# CITY OF HOUSTON

**RE: Loop 494 from north of Kingwood Drive to Sorters-McClellan Road  
CSJ 0177-14-10; CSJ 0177-15-003**

Engineers in our Traffic and Transportation Division have reviewed the 30 % preliminary design plans for the aforementioned project. Our specific concerns are the sight distance and vehicle storage issues for Kingwood Drive motorists traveling over the vertical curve caused by the elevated railroad tracks just east of Loop 494. We request the roadway pavement west of the railroad tracks be elevated to match the elevation of the railroad tracks to improve traffic operation. In the future when the City widens Kingwood Drive to a 6-lane cross-section, we will address raising the roadway to the east of the railroad tracks.

RE: Loop 494 from north of Kingwood Drive to Sorters-McClellan Road  
Proposed Improvements along Kingwood Drive

<b>CITY OF HOUSTON</b>	
DEPARTMENT OF PUBLIC WORKS AND ENGINEERING	
<b>STREET WIDENING AND STRIPING PLAN</b>	
<b>KINGWOOD BLVD @ LOOP 494</b>	
FILE NO.: Kingwood.dwg	
GPS NO.	
DATE: 06/22/08	
SCALE: Not to Scale	
CITY OF HOUSTON P.N. 09006	
P.M.: G. SCHWITZ	
SHEET NO. 1 OF 1

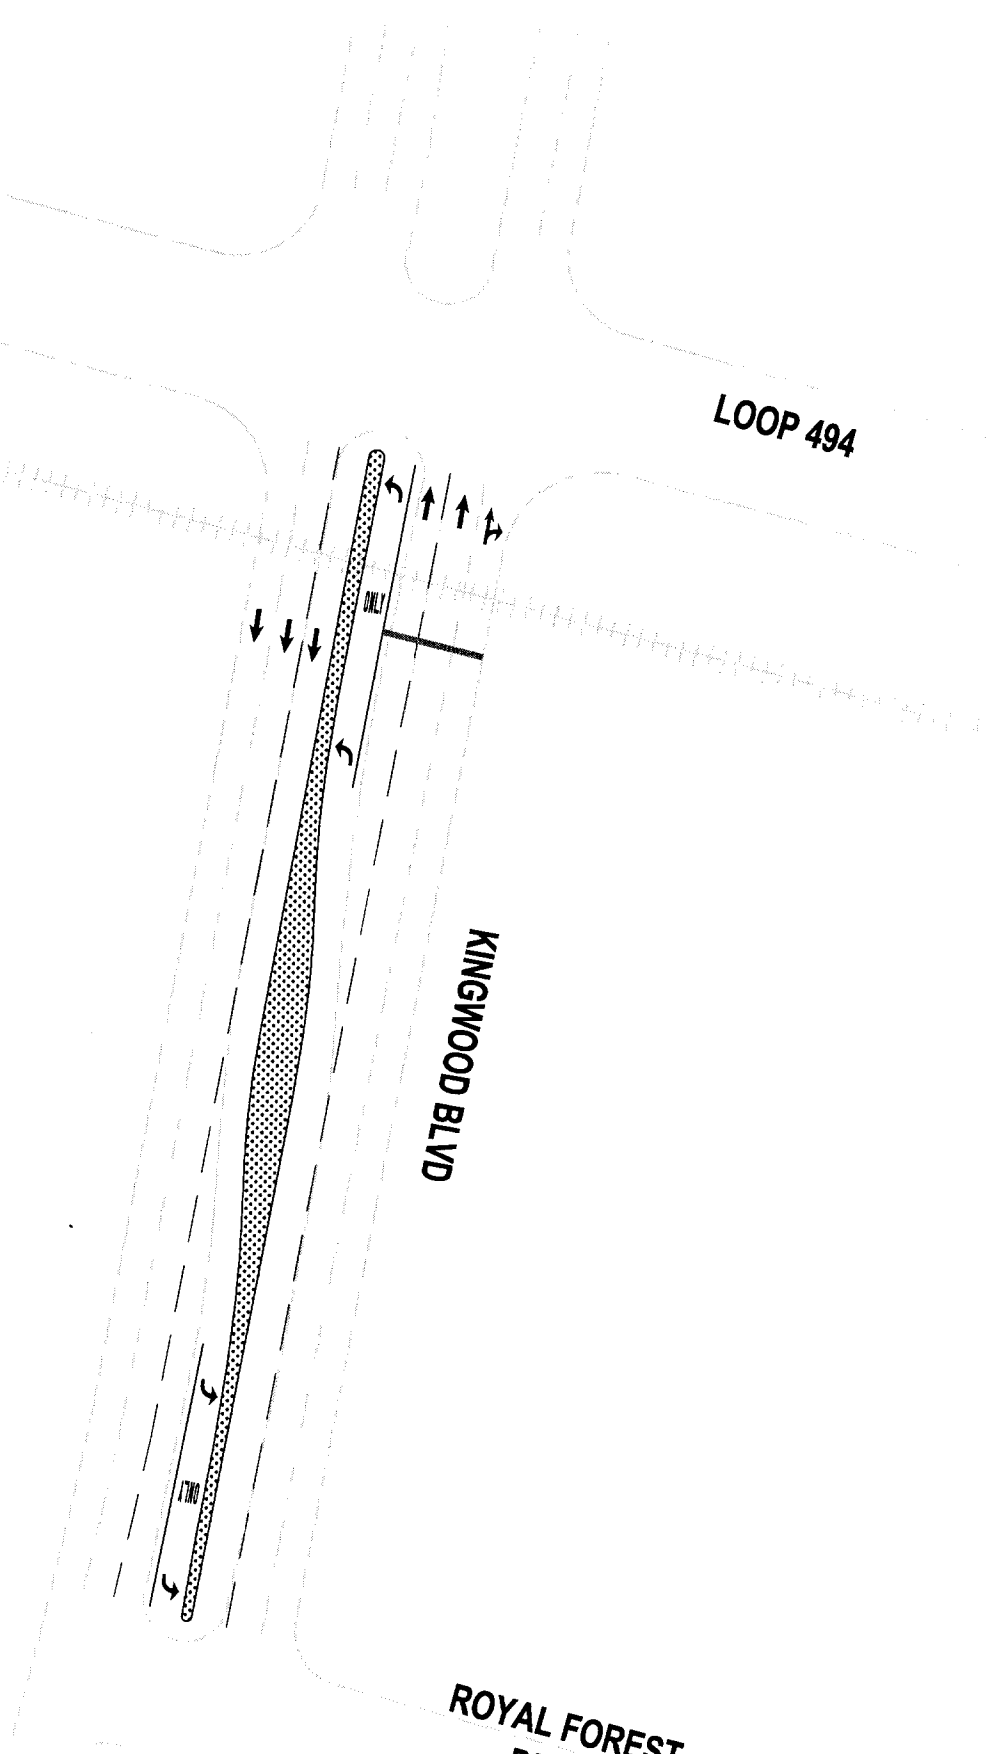
Please find attached our conceptual design for Kingwood Drive immediately east of Loop 494. Any future widening of Kingwood Drive would be accomplished by holding the outside curb lines in place and making improvements within the existing esplanades, ultimately resulting in a six-lane divided roadway with left turn lanes at key locations. Additionally, the profile of Kingwood Drive immediately east of Loop 494 would be raised to be approximately equal to the elevation of the Union Pacific Railroad crossing.
